Comments and Questions on Draft CTPG Phase 3 Study Report

We appreciate the work that CTPG is doing and we value the opportunity you have given to the various stakeholders to submit alternatives to be studied under the CTPG process. On behalf of our Clients, we have reviewed your draft and are providing the following comments, questions and observation on the (1) Green Energy Express (GEET), a double circuit, 500 KV AC line (2) Metro Renewable Express Project “MRE”, two underground DC line with 2,000 MW rating from Devers to Mira Loma (3)The Pony Express Project “PE” from El Dorado to Devers 500 KV, AC line and (4) Clean Path Energy project connecting Los Banos – Westley through a new single or double 230 KV AC line.

Figure 1 – basecase configuration showing the new Colorado River Valley 500kV

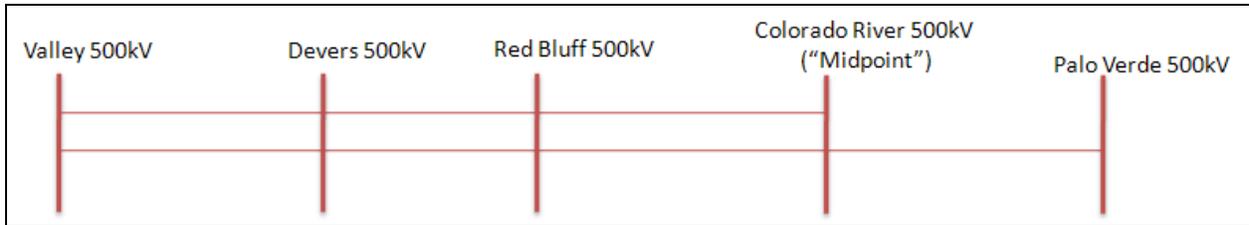
Q34. Table 2.1 outlines the Transmission upgrades added or removed from the Seed Case in order to produce the CTPG cases. In the first column titled “Upgrades with Key Regulatory Approvals and Environmental Permits” CTPG lists the following upgrades around Devers:

- a. New Colorado River (“Midpoint”) 500kV Substation looping in existing Palo Verde-Devers #1line
- b. 500kV Colorado River-Devers #2 line
- c. 500kV Devers-Valley #2 line

Please confirm that the configuration in Figure 2 represents the CTPG base case. Also our analysis shows that the GEET with one line from Eagle – Red Bluff – Devers and the second circuit is from Eagle to Devers results in higher reliability than the Red- Bluff Devers 500kv line that was modeled in the base case. This GEET configuration provides incremental benefits of interconnecting higher number of renewable with minimum incremental cost. Please analyze a scenario that represents the GEET configuration in the base case instead of the Red Bluff –Devers to examine which alternative provide a superior reliability?
